SUNDRY NOTICES AND REPORTS ON WELLS (DO NOT USE THIS FORM FOR PROPOSALS TO DRILL OR TO DEEPEN OR PLUG BACK TO A DIFFERENT RESERVOIR. USE "APPLICATION FOR PERMIT" (FORM C-101) FOR SUCH PROPOSALS.)		WELL API NO. 30-025-25272
1. Type of Well: Oil Well ☒ Gas Well ☐ Other ☐		5. Indicate Type of Lease STATE ☒ FEE ☐
2. Name of Operator Maverick Permian LLC		6. State Oil & Gas Lease No. OG-453
3. Address of Operator 1000 Main Street, Suite 2900 Houston, TX 77002		7. Lease Name or Unit Agreement Name Supco State
4. Well Location Unit Letter <u>F</u> : 1980 <u> </u> feet from the <u>North</u> line and <u>1980</u> feet from the <u>West</u> line Section 17 Township 17S Range 34E NMPM County Lea		8. Well Number 001
11. Elevation (Show whether DR, RKB, RT, GR, etc.)		9. OGRID Number 331199
10. Pool name or Wildcat Vacuum; ABO, North

Maverick Permian LLC respectfully requests approval to Plug and Abandon the Supco State #001 using the following plan:

Maverick Natural Resources
Well: Supco State #1
API# 30-025-25272

Operator: Maverick Permian LLC 1000 Main Street, Suite 2900 Houston, TX 77002	OGRID: 331199
	Action Number: 316392
	Action Type: [C-103] NOI Plug & Abandon (C-103F)

Current WBD
2.7.24
Drawn by: J. Carter, Maverick Natural Resources.

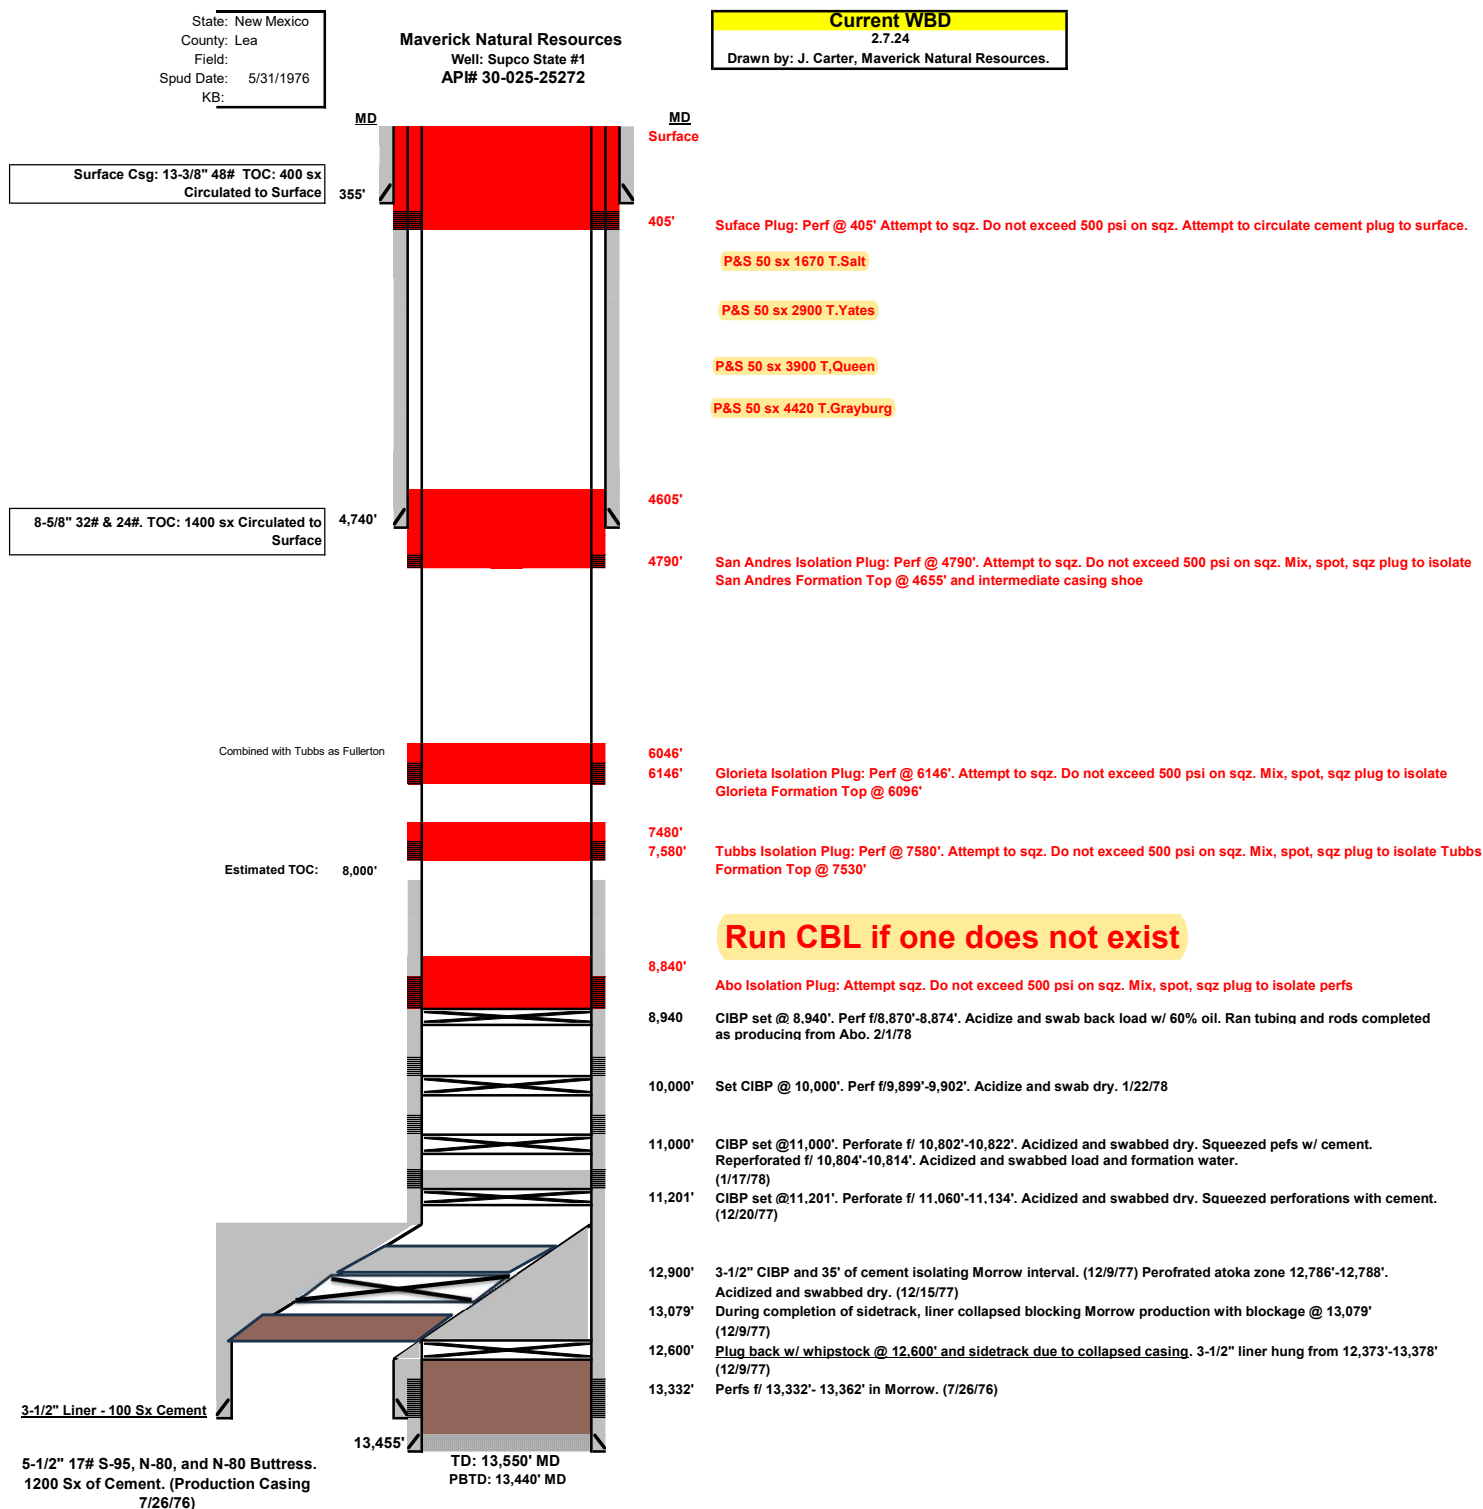
Note changes to procedure

RUN CBL if none on file

4790' - 4605' San Andres isolation plug: Perf @ 4790', attempt to sqz, do not exceed 500 psi on sqz. Mix, spot, sqz plug to isolate San Andres formation tops @ 4655' and intermediate casing shoe. **P&S 50 sx 4420 T.Grayburg P&S 50 sx 3900 T.Queen P&S 50 sx 2900 T.Yates P&S 50 sx 1670 T.Salt**

Created By	Condition	Condition Date
kfortner	See attached COA Note Changes to Procedure	2/22/2024
